Plug and Abandonment Procedure
for
DJR Operating, LLC
Jicarilla Apache B 1
API # 30-039-60024
NE/SW, Unit F, Sec. 20, T24N, R5W
Rio Arriba County, NM

Attachment to notice of Intention to Abandon

Well: Jicarilla Apache B 1

BLM FLUID MINERALS P&A Geologic Report

DJR Operating, LLC
Proposed Wellbore Diagram
Jicarilla Apache B 1
API # 30-039-60024
SE/NW, Unit F, Sec 20, T24N, R5W
Rio Arriba County, NM

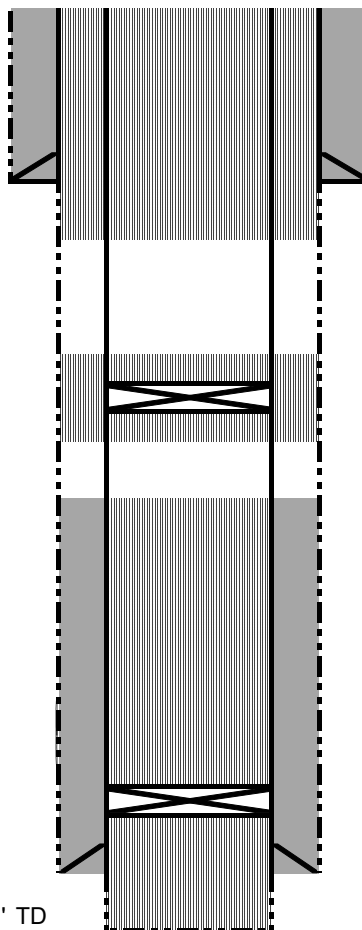
You are also required to place cement excesses per 4.2 and 4.4 of the attached General Requirements.
